**Item No. 9.1.2**  
**Design Review Committee**  
**November 21, 2022**

**SUBJECT:** **Case 24497: Substantive Site Plan Approval for 1190 Barrington Street,  
Halifax**

# Attachment A: Site Plan Approval Plans

dwg no: A-100  
rev. 3: Oct. 5, 2022

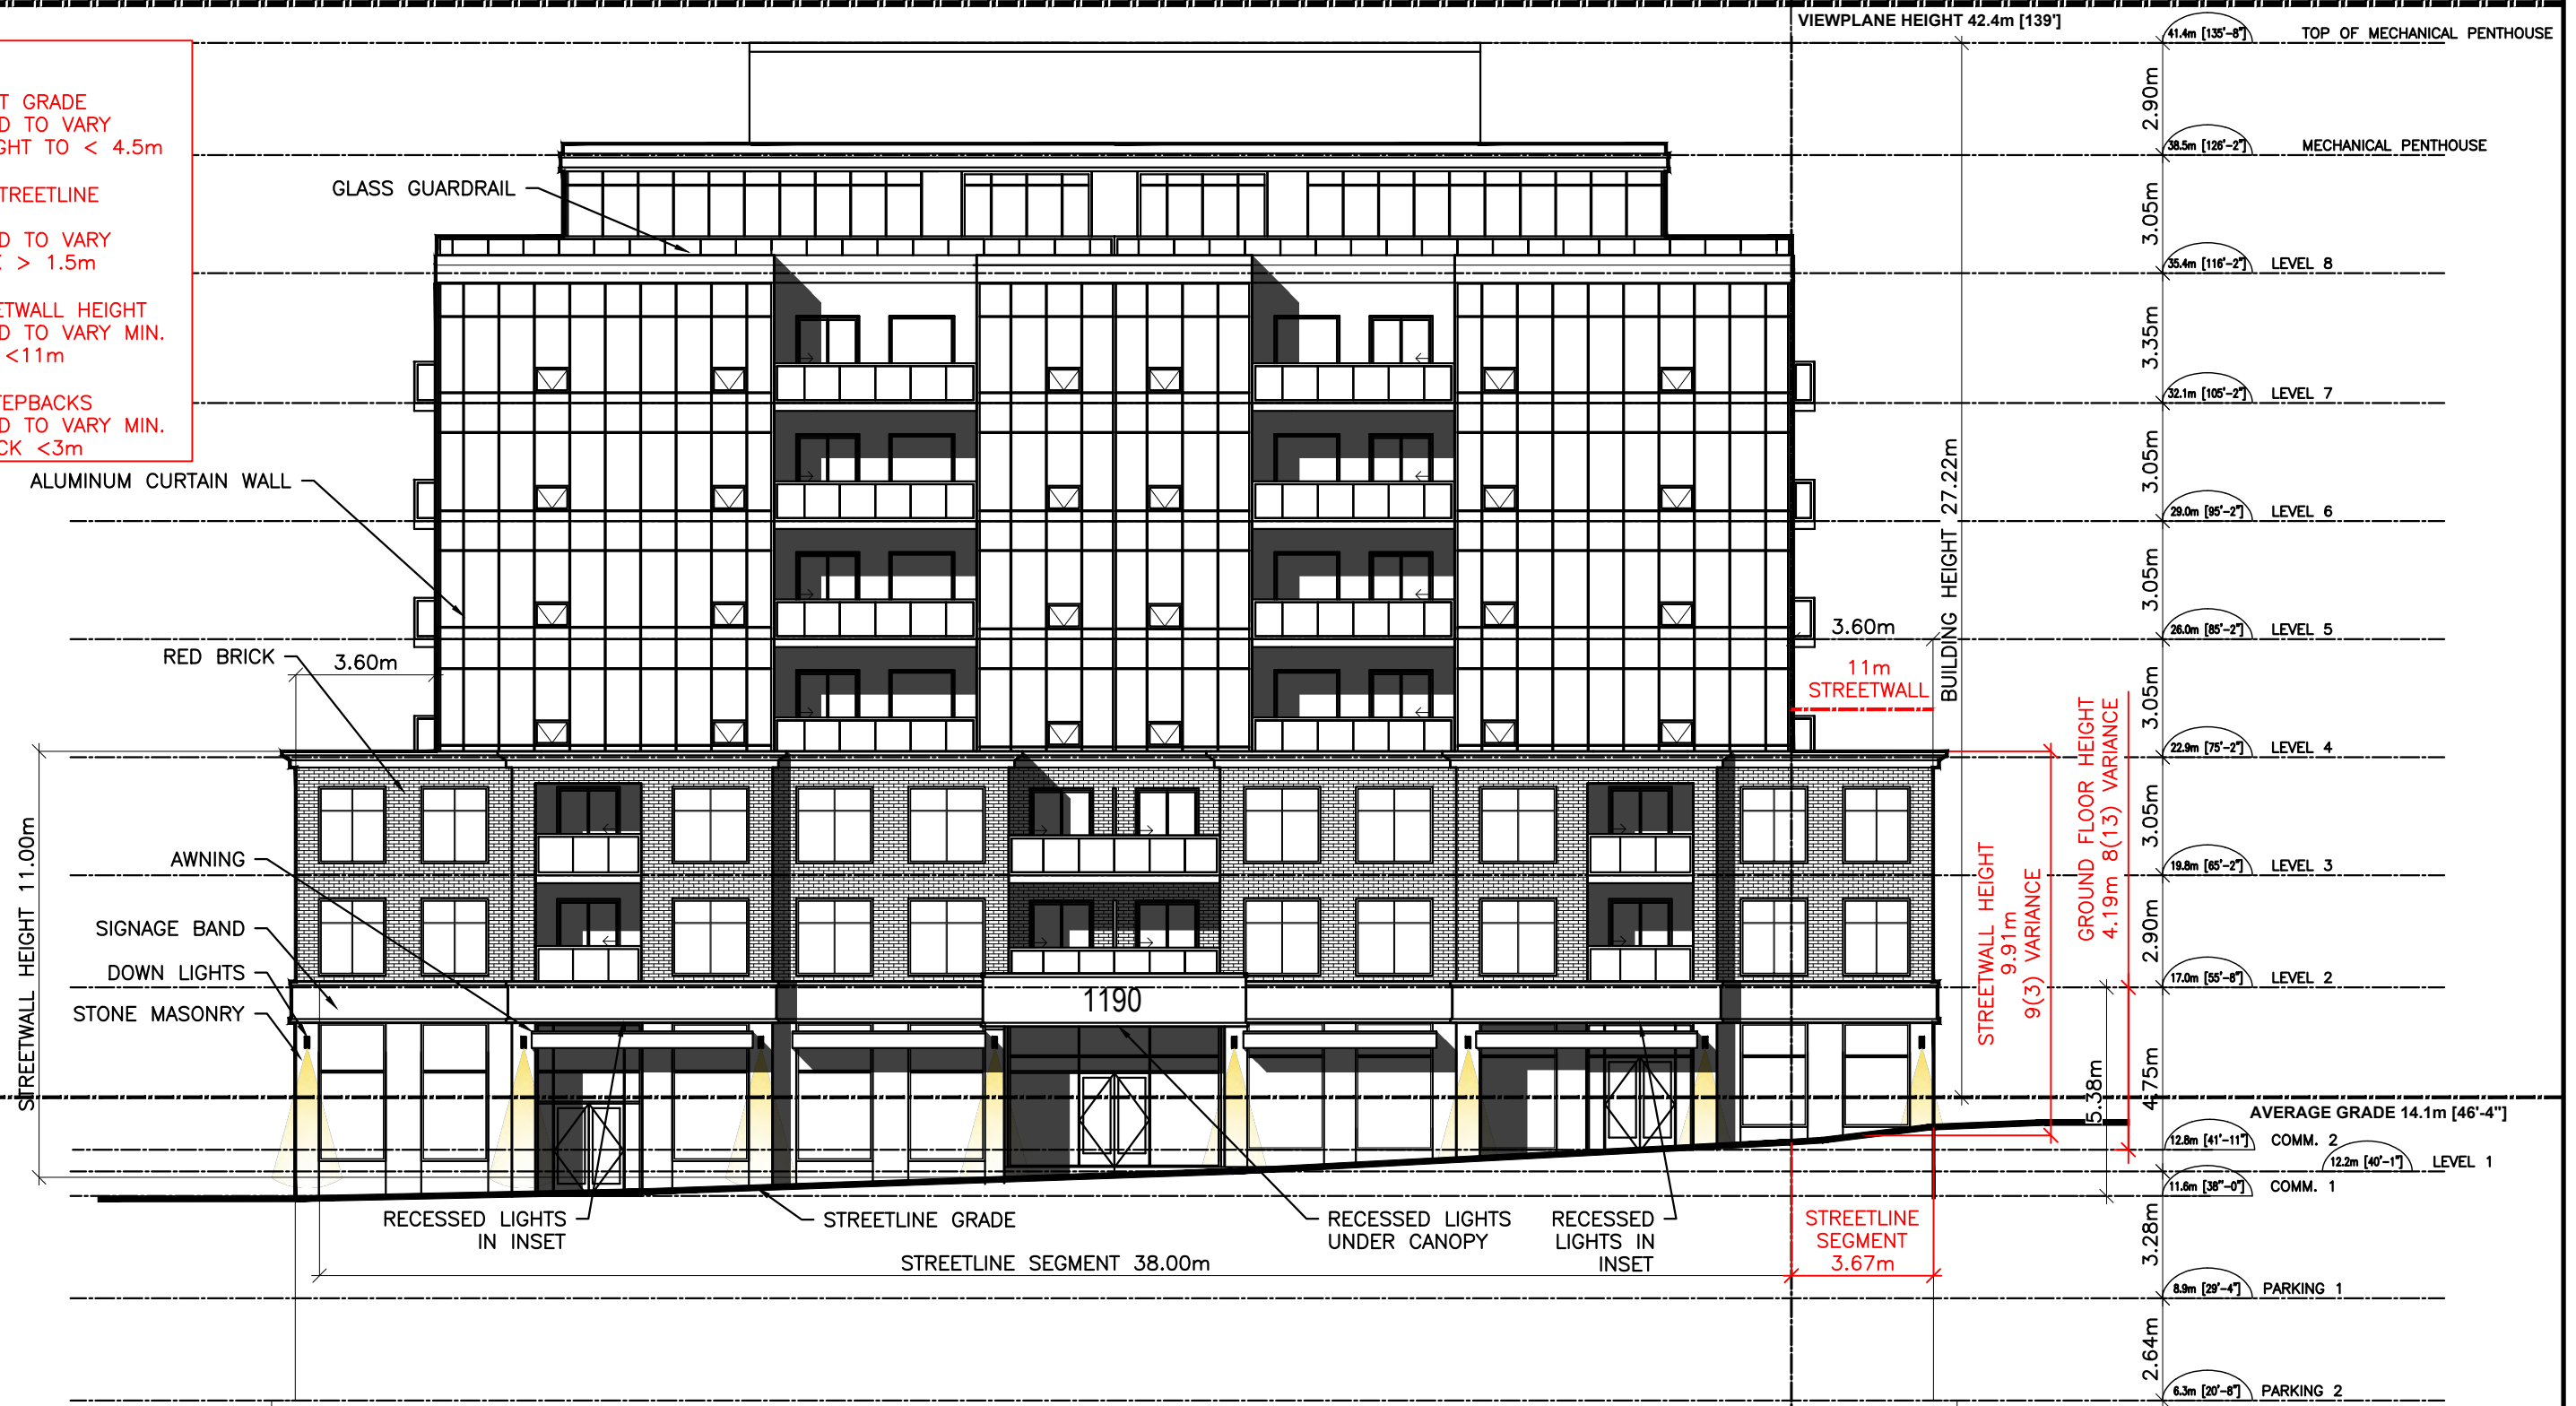
8(13) LAND USES AT GRADE  
 VARIANCE REQUESTED TO VARY  
 GROUND FLOOR HEIGHT TO < 4.5m

9(1) STREETWALL: STREETLINE  
 SETBACK  
 VARIANCE REQUESTED TO VARY  
 STREETLINE SETBACK > 1.5m

9(1) STREETWALL: STREETLINE  
 SETBACK  
 VARIANCE REQUESTED TO VARY  
 STREETLINE SETBACK > 1.5m

9(3) MINIMUM STREETWALL HEIGHT  
 VARIANCE REQUESTED TO VARY MIN.  
 STREETWALL HEIGHT < 11m

dwg no:  
**A-202**  
 rev. 3: Oct. 5, 2022

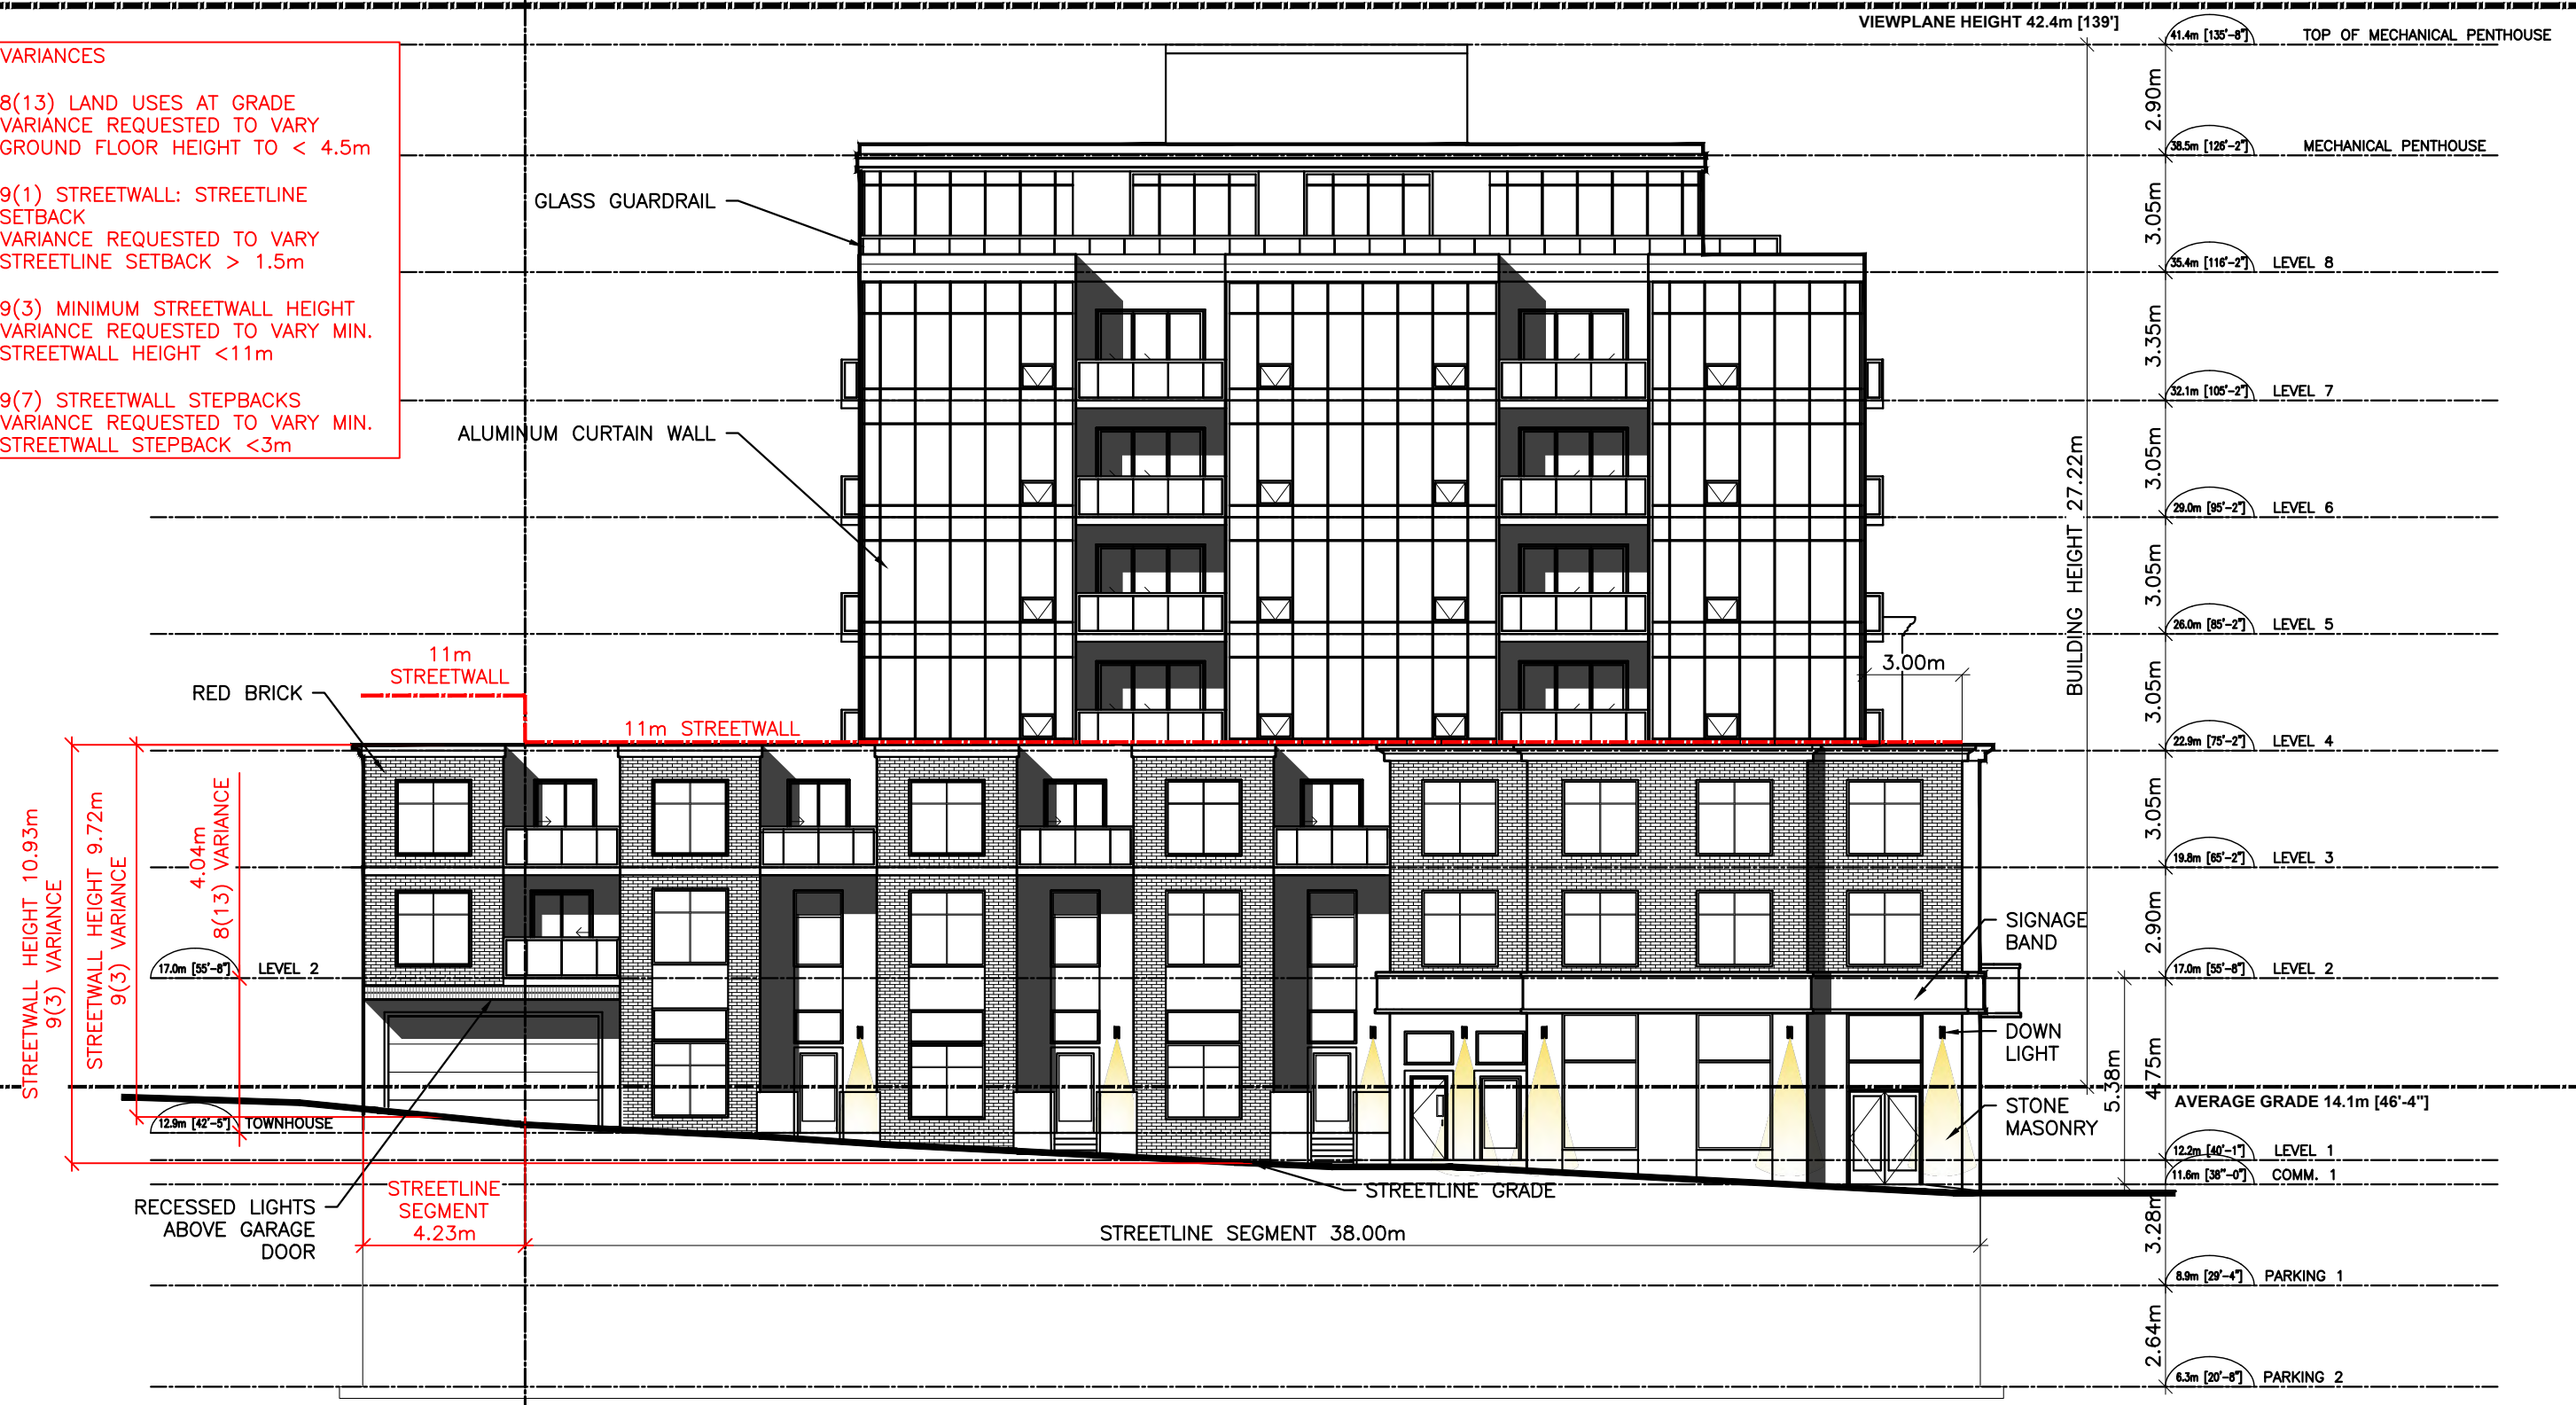
9(7) STREETWALL STEPBACKS  
 VARIANCE REQUESTED TO VARY MIN.  
 STREETWALL STEPBACK < 3m

Fig. 8. North Wind Existing  
**EXISTING CONDITIONS**

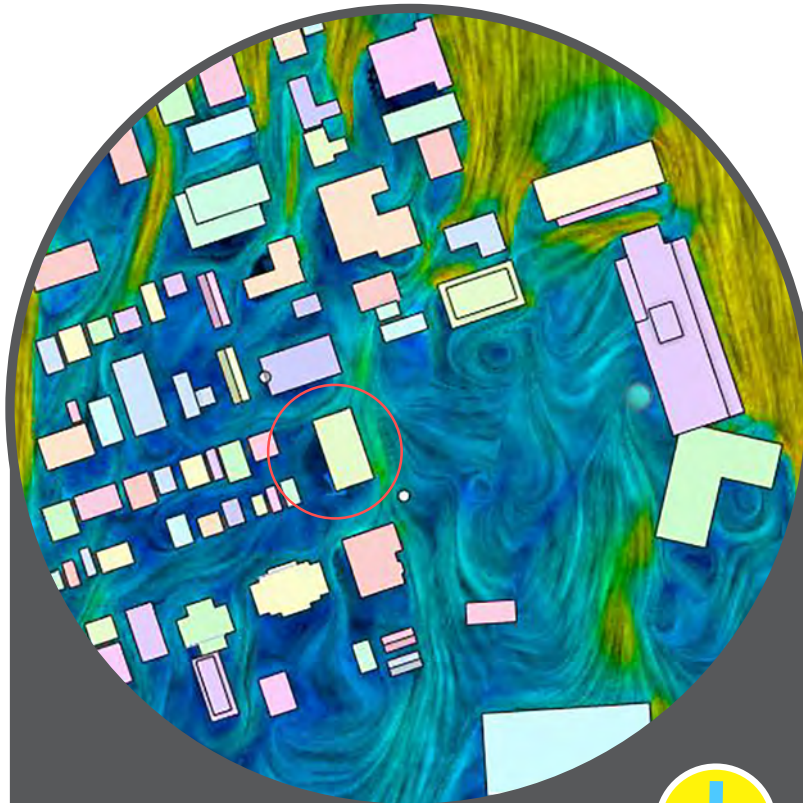
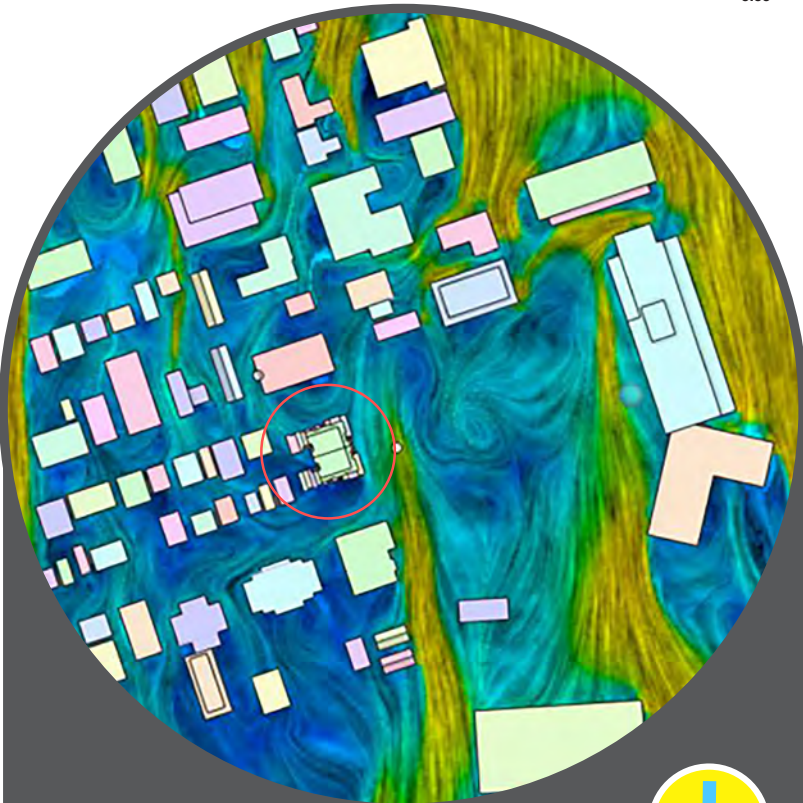
Winds from the north are not overly frequent in the summer, but are a little more frequent in the winter. For example, wind speeds over 30 km/hr only happen about 1-2% of the time in the winter and less than .5% of the time in the summer. The CFD simulation was set to start in the windiest conditions starting at 20m/s (Yellow) in order to model a worst case scenario for pedestrian comfort. Areas in orange and red are areas where wind speeds will be accelerated at a higher wind speed than the starting wind speed (>20 m/s).

Looking at the existing and future conditions, the wind shadow is slightly more pronounced (see purple and blue areas) in the future condition south and west of the new building. Wind speeds may be slightly more elevated along Barrington Street south of the new development after it is constructed. In Cornwallis park across the street, there will be slightly windier conditions along the west side of the park and slightly less windy conditions in the middle of the parks. Overall, the northern wind direction seems to create the most noticeable impacts along Barrington Street when comparing the existing buildings to the new 8-storey building.

Fig. 14. South-west Wind Existing

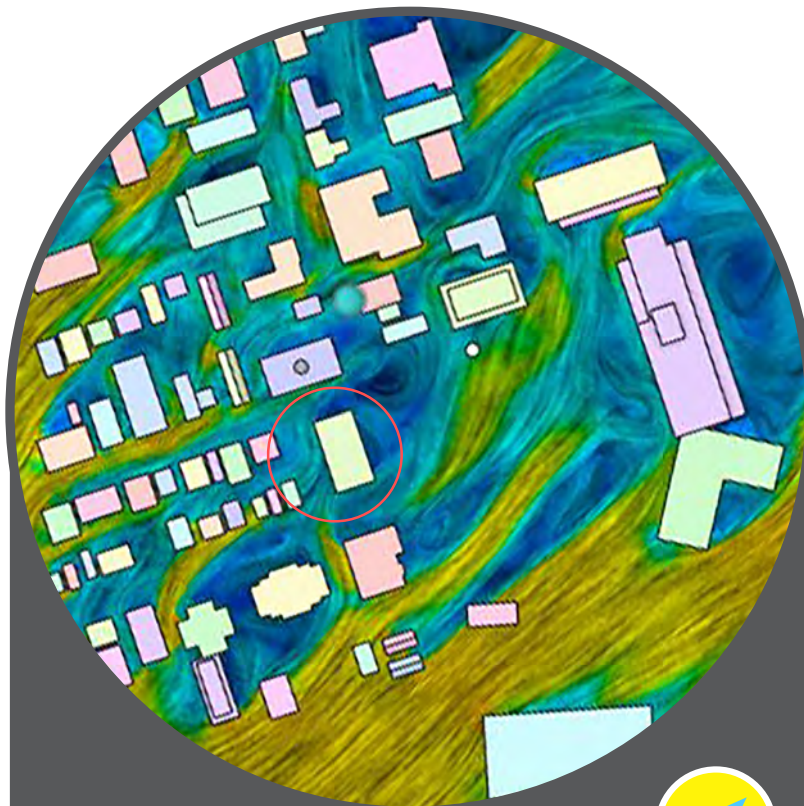
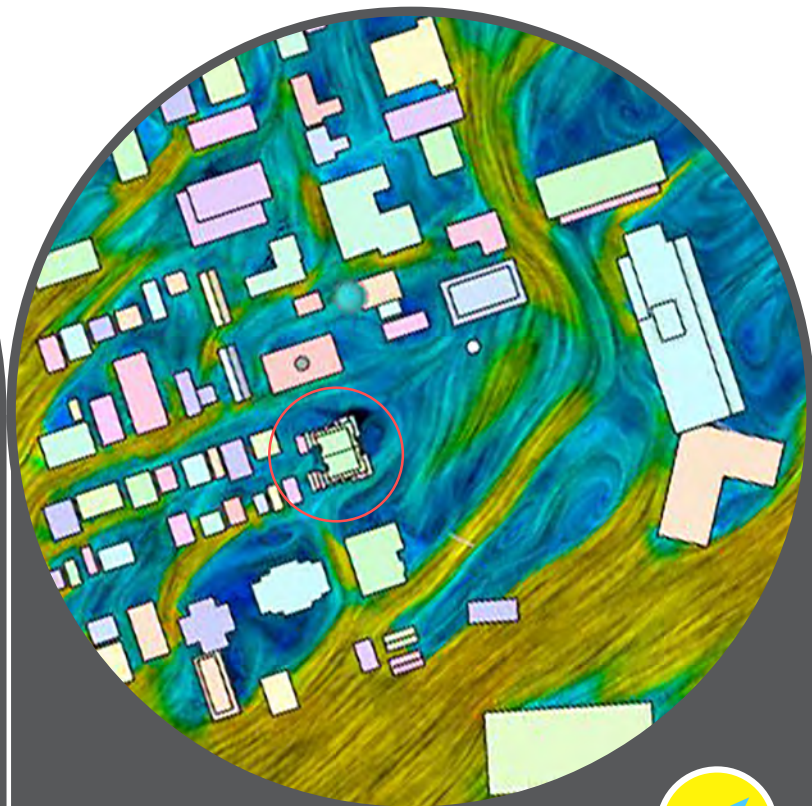
Comparing the existing and future wind condition maps, the new building decreases wind speeds on Barrington Street and in Cornwallis Park. The corner of Hollis and Barrington Street will be slightly windier than today but some of the Superstore parking lot will be less windy than it is Today.
